APPLICATION NO.	FILING DATE	FIRST NAMED INVENTOR	ATTORNEY DOCKET NO.	CONFIRMATION NO.
10/602,054	06/24/2003	Dae-Ho Choo	61920219D1	1023

## Office Action Summary

## **DETAILED ACTION**

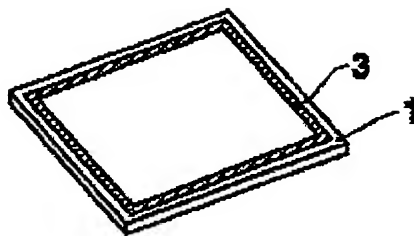
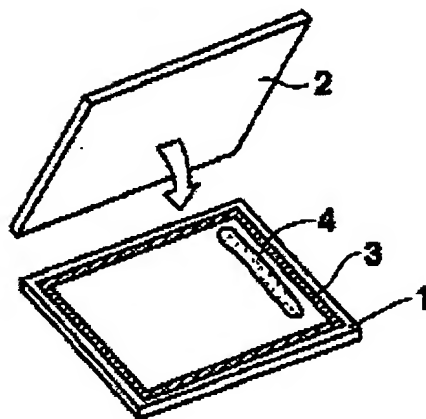
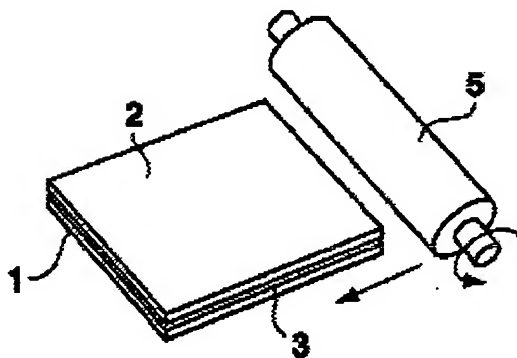
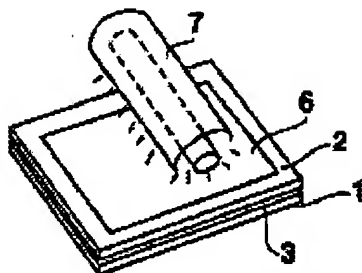
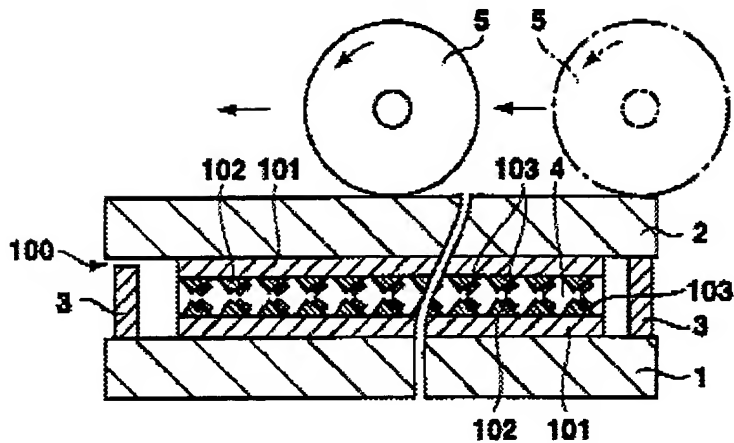
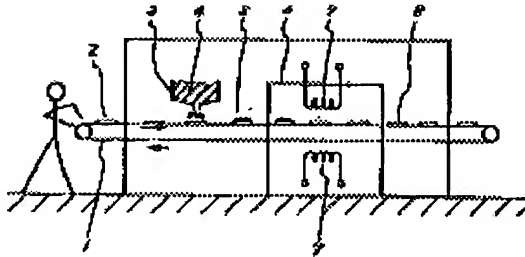
As to claim 1, Kawasumi discloses (Figures 1A-3B) apparatus and a method for manufacturing liquid crystal displays (entire patent, background of the invention, and especially col. 5, line 13 through col. 7, line 14), comprising: applying sealant on one of two substrates of a mother glass, the mother glass having at least one liquid crystal cell (col. 5, lines 14-37) [inherently requires Applicant's sealant applying unit, even if it is manual], a substrate-attaching unit, 5 and 7, conjoining substrates in a vacuum (background, suitable though more costly method – affords better degasification of liquid crystal material). Please note numerous references teach these steps/apparatus.

Kawasumi does not explicitly disclose the use of an in-line conveying unit.
